***Development Special Use Permit #2019-0024
Transportation Management Plan SUP # 2019-0087
Carlyle Plaza Two – 760 John Carlyle Street, 1700 & 1800
Eisenhower Avenue, 800 Bartholomew Street***

Application	General Data	
Project Name: Carlyle Plaza Two Extension Location: 760 John Carlyle Street, 1700 & 1800 Eisenhower Avenue, 800 Bartholomew Applicant: Carlyle Plaza, LLC, represented by Jonathan P. Rak, Attorney.	PC Hearing:	November 7, 2019
	CC Hearing:	November 16, 2019
	If approved, DSP Expiration:	November 16, 2027
	Plan Acreage:	6.23 acres (271,222 sf)
	Zone:	CDD #11 (South Carlyle)
	Proposed Use:	Office, Residential, Hotel, and Open Space
	Gross Floor Area:	632,056 sf – Residential 755,114 sf – Office (with allowance for conversion of up to 250,000 sf to Hotel and 125,000 sf to additional Residential) 1,387,170 sf - Total
	Small Area Plan:	Eisenhower East
	Green Building:	Will comply with 2019 Green Building Policy

Purpose of Application
Consideration of a request for the extension of a development special use permit and site plan (DSUP #2013-0025), and a Transportation Management Plan, with an update to conditions, under Section 11-418 of the Zoning Ordinance.
Staff Recomm

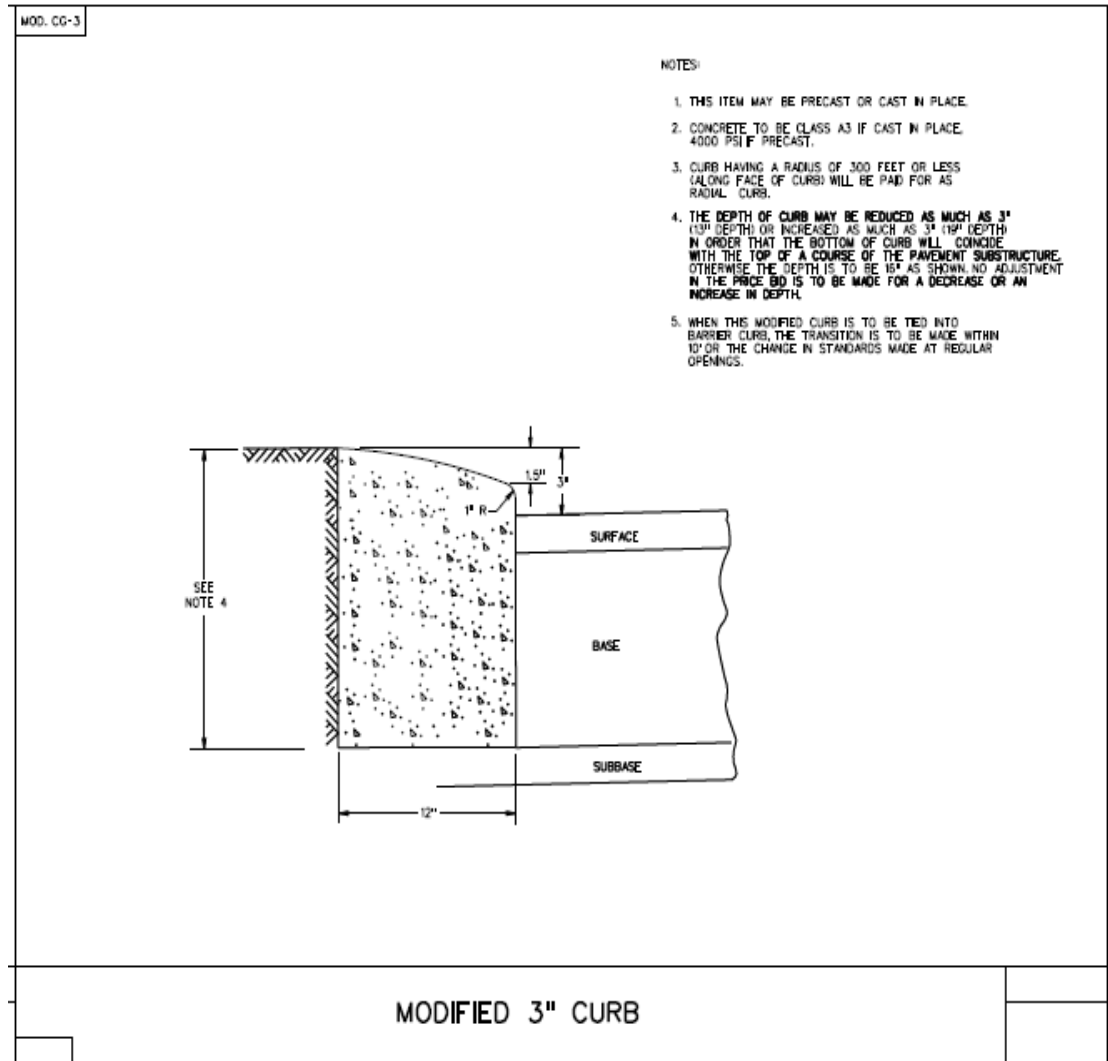
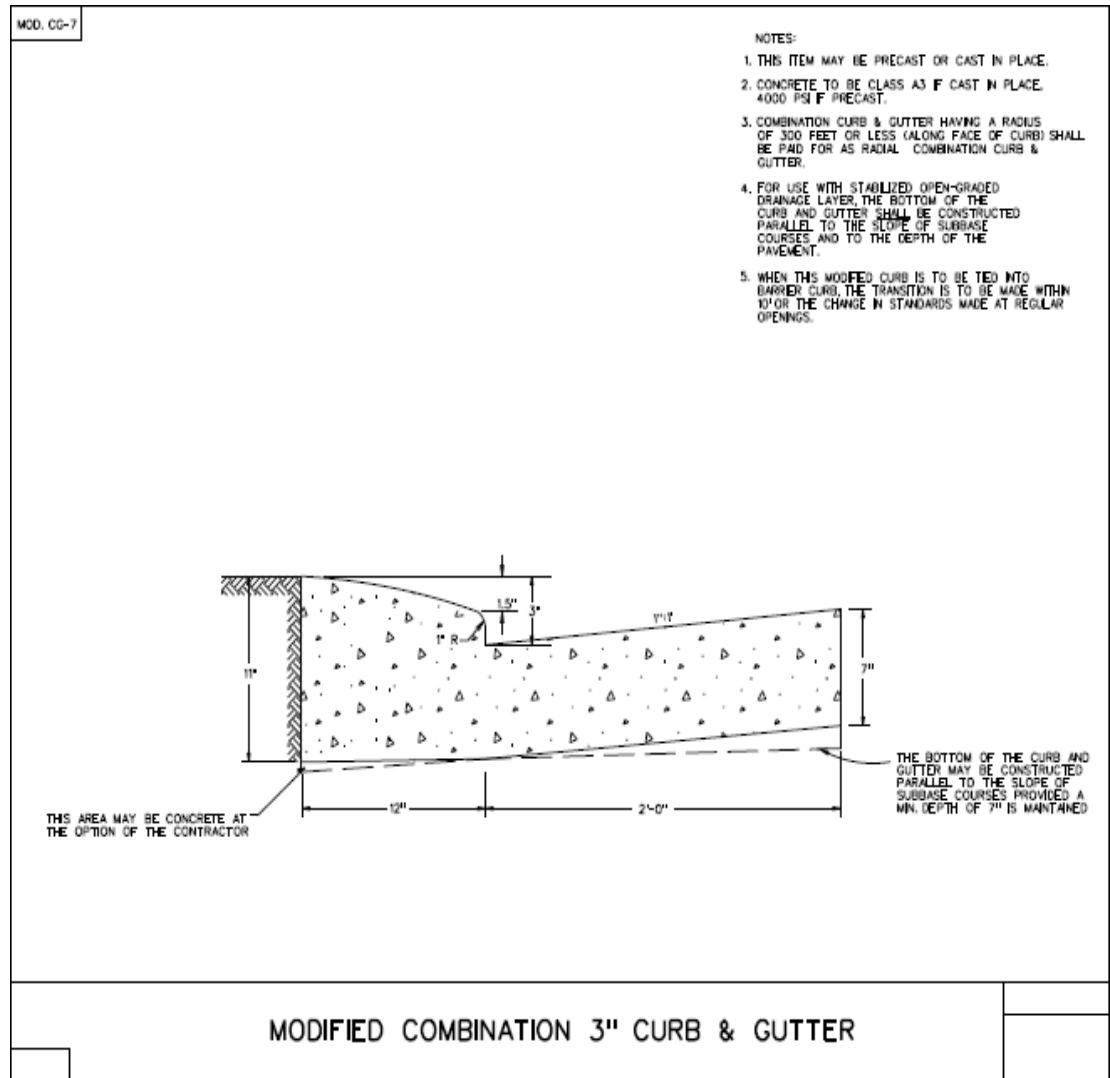
C - 7 CODE REQUIREMENT AMENDED BY STAFF (DSUP2019-0024): The **fire service plan final site plans** shall show placement of emergency vehicle easement signs. See sign detail and placement requirements **below are as follows.**

Emergency vehicle easements shall be a minimum of 22 feet across the travel lane. The emergency vehicle easement shall provide access to strategic areas

of the building and fire protection systems. Curbing and street components shall conform to the standards established by Transportation and Environmental Services and this document for emergency vehicle easements. Emergency vehicle easement signs shall be metal construction, 12-inches wide and 18 inches in height. Provide red letters on reflective white background with a 3/8-inch red trim strip around the entire outer edge of the sign. The lettering shall say "NO PARKING," "FIRE LANE," "EM. VEH. EAS.," and "City of Alex.," Lettering size shall be as follows: "NO PARKING" - 2 inches, "FIRE LANE" - 2½ inches. EM. VEH. EAS. - 1 inch, CITY OF ALEX. - ½ inch. Directional Arrows - 1 inch by 6 inches solid shaft with solid head - 1½ inches wide and 2 inches deep (For examples, see Figures D102.1, D102.2, and D102.3). Signs shall be mounted with the bottom of the sign 7 feet above the roadway, and shall be properly attached to a signpost or other approved structure such as designated by the fire official. Posts for signs, when required, shall be metal and securely mounted. Signs shall be parallel to the direction of vehicle travel and posted so the directional arrows clearly show the boundaries and limits of the Emergency Vehicle Easement. In areas where emergency vehicle easements involve two-way traffic, double mounted signs shall be provided. The maximum distance between signs shall be 100 feet. Other special signs or modifications to emergency vehicle easement signs shall be approved by the fire official.

Where curbing is a component of the emergency vehicle easement, the curbing construction shall conform to weight and grade requirements for vehicular traffic. In no circumstances shall a raised curb be located in the path of travel in an emergency vehicle easement. Where a mountable curb is provided as part of an emergency vehicle easement, emergency vehicle easement signs shall be posted at the point nearest the edge of the emergency vehicle easement, but in no case within the clear width of the emergency vehicle easement. With the exception of flush curbs, any fire department access points that require fire apparatus to mount a curb shall conform to the modified 3 inch curb design standard MOD CG-3 or MOD CG-7 design as shown.
